# PLANNING COMMISSION AGENDA REPORT

MEETING DATE: JUNE 23, 2025

**SUBJECT: DESIGN REVIEW (PDES-24-0013) AND TENTATIVE PARCEL MAP 2024-156 FOR A RESIDENTIAL SMALL LOT SUBDIVISION TO CREATE TWO PARCELS EACH CONTAINING A NEW TWO-STORY DETACHED SINGLE-FAMILY RESIDENCE AND AN ATTACHED TWO-CAR GARAGE AT 2280 ELDEN AVENUE**

**Exhibit 3 Proposed Parcel Map**

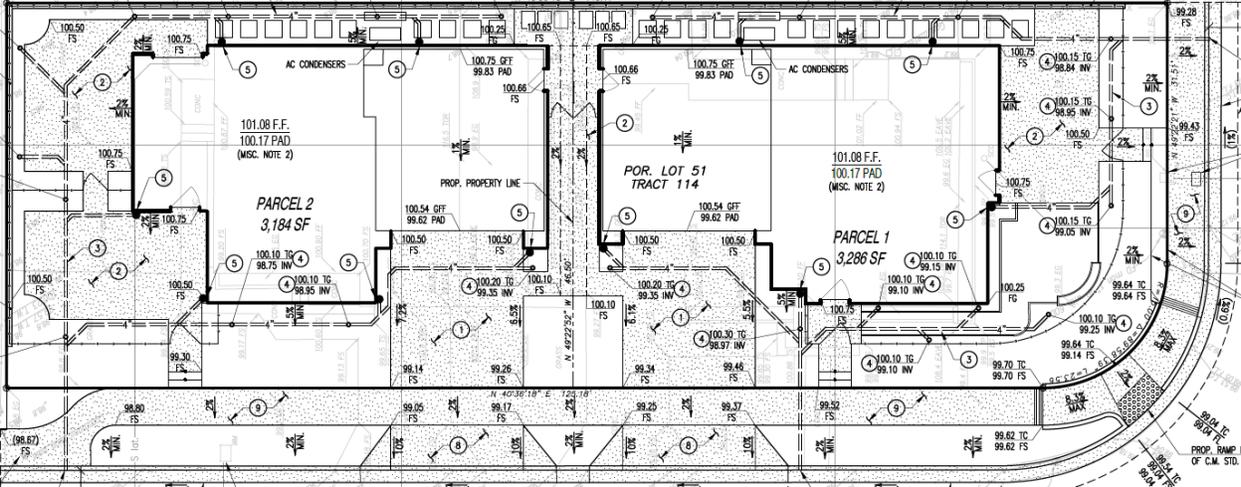
The proposed development, as shown in exhibit 3 below, will subdivide the 6,470-square-foot parcel into two parcels. Parcel 1 is proposed to be 3,286 square feet and parcel 2 is proposed to be 3,184 square feet. Each parcel proposes a two-story single family residence with an attached two-car garage oriented towards Elden Avenue.

The existing 6,470 square-foot corner property is rectangularly shaped and is 140 feet deep and 46.5 feet wide. The Tentative Parcel Map application proposes the creation of two lots consisting of Parcel 1 (3,286 square feet) and Parcel 2 (3,184 square feet). Parcel 1 is proposed relatively rectangular shaped on the corner of the intersection with 56 feet 8 inches of street frontage on Elden Avenue, and Parcel 2 is proposed to be located side adjacent to Parcel 1 as an interior lot with an approximate 68 feet 5 inches of street frontage on Elden Avenue. The City's Residential Small Lot Subdivision standards do not require a minimum lot size.

**Exhibit 6 Conceptual Landscape Plans**

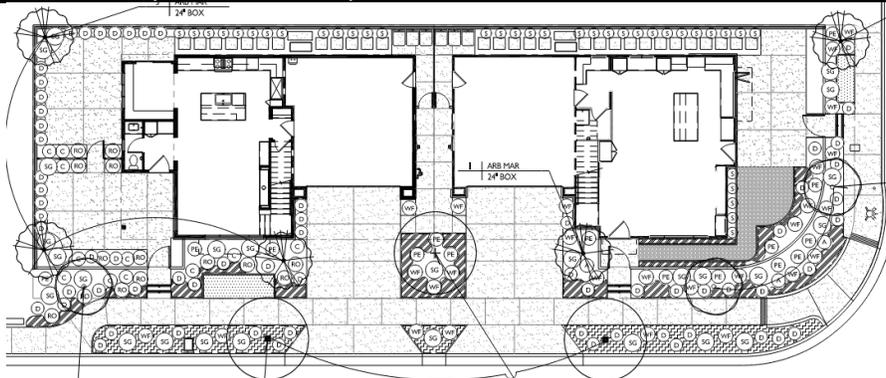
Per CMMC Section 13-106, all required landscape areas shall consist of drought tolerant plant material and shall meet the minimum number of plant types based on the total landscape square footage. The project proposes a total of 1,785 square feet of landscaping with a mixture of usable and decorative landscaping. The number of plants and trees required and proposed is provided in Table 3 below.

Two street trees will also be proposed to further improve the site. As part of the building permit plan check review, landscape plans will be prepared and certified by a California licensed landscape architect confirming compliance with the CMMC and water efficiency landscape guidelines (see Exhibit 6 which shows the proposed landscape plans for Parcels 1 and Parcel 2).
